Comment on "Planar Hall resistance ring sensor based on NiFe/Cu/IrMn trilayer structure" [J. Appl. Phys. 113, 063903 (2013)]

Frederik Westergaard Østerberg, Anders Dahl Henriksen, Giovanni Rizzi, and Mikkel Fougt Hansen

FIG. 1. Sketch of (a) Ring and (b) PHEB sensors with definitions of dimensions and angles. $\hat{I}$ is a vector along the current forming an angle α to the x-direction.

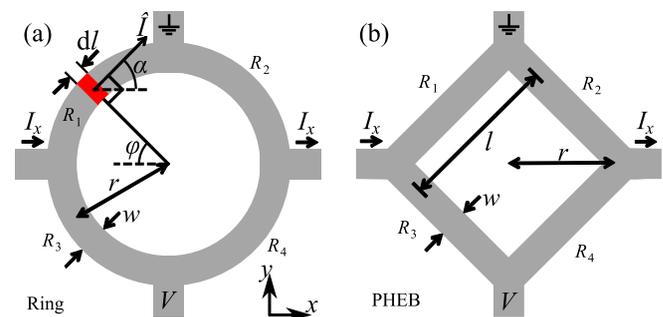
In a recent paper, Sinha *et al.*[1] compare sensitivities of planar Hall effect sensors with different geometries that are all based on the anisotropic magnetoresistance of permalloy. They write that the sensitivity of a planar Hall effect sensor with a ring geometry as shown in Fig. 1(a) is a factor of $\sqrt{2}$ larger than the sensitivity of the so-called planar Hall effect bridge (PHEB) sensor[2] of equal size with the geometry shown in Fig. 1(b). Sinha *et al.*[1] calculate the signal for a ring sensor to

where l is the length of each sensor branch. If the contacts to the two sensors are placed at identical positions, $l = \sqrt{2}\,r$, which leads to a ratio of Eq. (1) to Eq. (2) of $\pi/\sqrt{2}$ instead of the claimed $\sqrt{2}$.

However, we do not agree on the signal calculation for a ring sensor derived by Sinha *et al.*[1] We are able to follow the derivation of the sensor signal until their Eq. (4), which for a general Wheatstone bridge should read

which is a factor of π different from Eq. (5) in Sinha *et al.*[1]

Comparing Eq. (10) with Eq. (2), it is clear that the magnetic field sensitivity of the PHEB geometry of Fig. 1(b) is a factor of $\sqrt{2}$ times that of the ring geometry of Fig. 1(a), i.e., 41% larger. The reason for this can be understood directly from Eq. (5). The terms that are quadratic in either $\sin\alpha$ or $\cos\alpha$ are identical upon a sign change of α and hence cancel out for a symmetric bridge geometry. Therefore, the only term contributing to the bridge voltage for a symmetric bridge geometry is that proportional to $\sin 2\alpha$, which comes from the off-diagonal terms of the resistivity tensor. This term clearly assumes its maximum numerical value for $\alpha = \pi/4 + n\pi/2$ with n being an integer and all other values of α will reduce the effect of this term on the bridge voltage. This explains why the PHEB geometry in Fig. 1(b) shows a larger signal than the corresponding ring geometry in Fig. 1(a).

In addition, the length of each of the four sensor branches for the ring sensor is $r\pi/2$, which is 11% longer than the corresponding length of $l = \sqrt{2}\,r$ for the PHEB sensor. Thus, the total resistance of the ring sensor 11% is higher than that of the PHEB sensor. This unnecessarily added resistance contributes to the sensor power dissipation and the sensor noise.

The differences in experimentally observed field sensitivities reported by Sinha *et al.*[1] are due to different length over width ratios for the various sensor designs as well as differences in the magnetic stack. Moreover, the field response may be affected by shape anisotropy, which will influence the two designs differently.

$$V_{\mathrm{Ring}} = \frac{r}{2wt}I_x\Delta\rho\sin(2\theta), \quad (10)$$

In conclusion, we have analyzed the ring sensor design of Fig. 1(a) and compared it to the corresponding PHEB design of Fig. 1(b). Our analysis shows that the magnetic field sensitivity of the two sensor designs for identically behaving magnetic stacks is 41% higher for the PHEB design than for the ring design and that it can be achieved with an 11% lower bridge resistance.
